**UNITED STATES DEPARTMENT OF COMMERCE
Patent and Trademark Office**

Office Action Summary

Application No.
09/476,521

Applicant(s)
GROPP et al.

Fig. 1

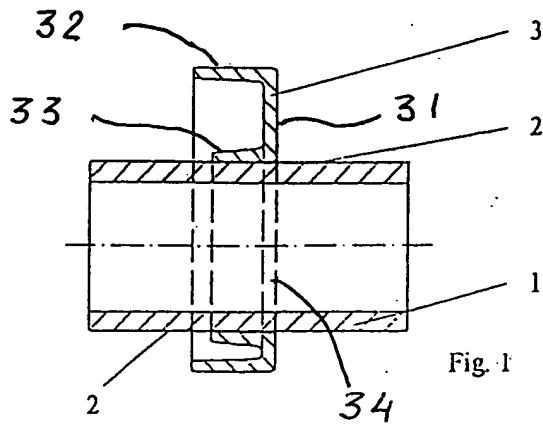
(C) The corrected Fig. 1 has been approved.

8. The original drawings are objected to because: (a) the drawings should show the plane upon which a sectional view such as Fig. 1 is taken; and (b) each part of the invention such as the outer diameter of the end piece should be designated by a referential numeral or character. Correction is required.

Fig. 2

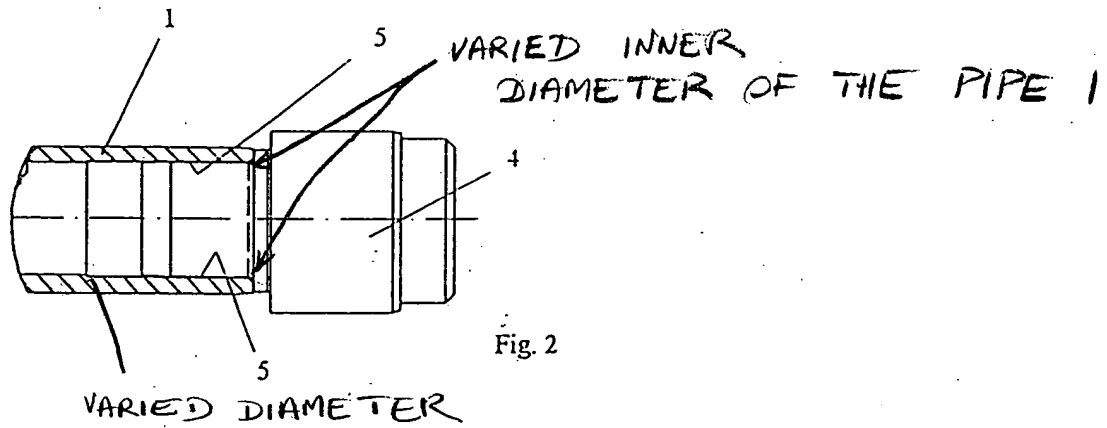
(a) new Fig. 4 introduces new matter such as the end piece 4 as now shown. The original Fig. 2 shows that the inner diameter of the pipe 1 is varied: (1) at the junction of the end piece 4 and the pipe 1 as shown by applicant's phantom line; and (2) at referential numeral 1 (see attached Exhibit). However, Fig. 4 shows that the inner diameter of the pipe 1 is constant. The original disclosure does not convey the concept that the inner diameter of the pipe 1 is constant, thus, it is unsupported by the record as filed. *In re Anderson*, 176 U.S.P.Q. 331 (CCPA 1973); and

Not
Approved
VL
10/20/00

Fig. 3

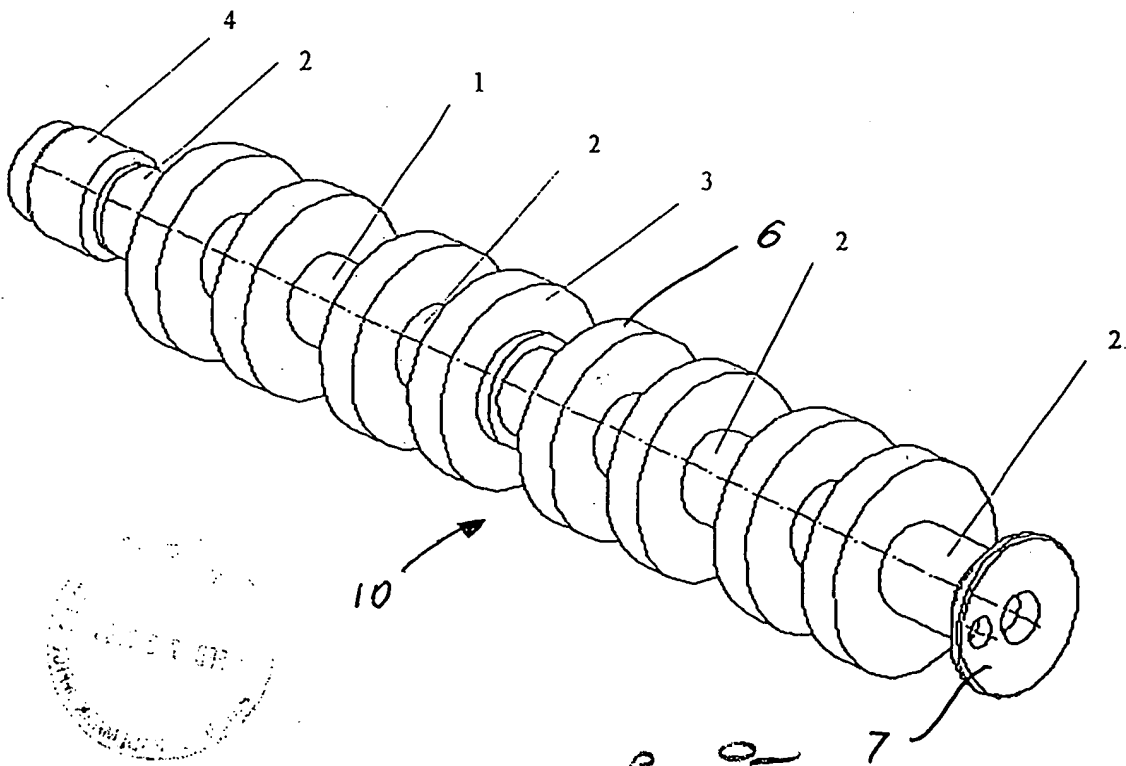
(B) The corrected Fig. 3 has been disapproved since it introduces new matter. The original drawings do not show the bearing rings. The corrected Fig. 3 now shows the bearing 6 which is identical to the cam 3. The showing and description of a specific type of bearing within a full spectrum of possible bearings is considered under the present disclosure to be new matter. *Cf., In re Smith*, 173 U.S.P.Q. 679 (CCPA 1972) and *Ex parte George*, 230 U.S.P.Q. 575, 578 (Bd. Pat. App. & Inter. 1986).

(C) the insertions in lines 13 and 14 on page 6 of the specification. The original drawings do not show the bearing rings. The corrected Fig. 3 now shows the bearing 6 which is identical to the cam 3. The showing and description of a specific type of bearing within a full spectrum of possible bearings is considered under the present disclosure to be new matter. *Cf., In re Smith*, 173 U.S.P.Q. 679 (CCPA 1972) and *Ex parte George*, 230 U.S.P.Q. 575, 578 (Bd. Pat. App. & Inter. 1986).

Fig. 4

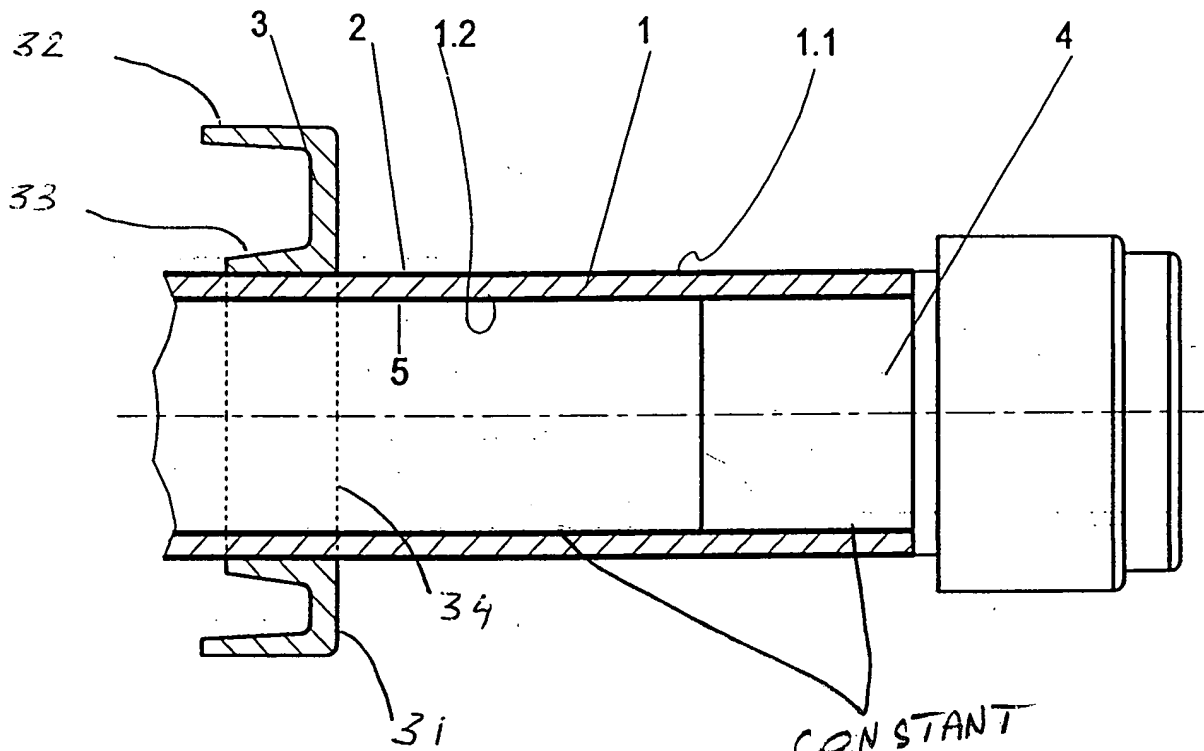
(A) New Fig. 4 has been disapproved because:

(b) new Fig. 4 is inconsistent with the description in Paper No. 9. The insertion on page 6, line 12 of the specification, states that the outer diameter of the end piece 4 is slightly larger than an inner diameter of the pipe 1. However, Fig. 4 shows that the outer diameter of the end piece 4 is equal to an inner diameter of the pipe 1.

Disapproved
VL
10/20/00

CONSTANT
DIAMETER
(NEW MATTER)
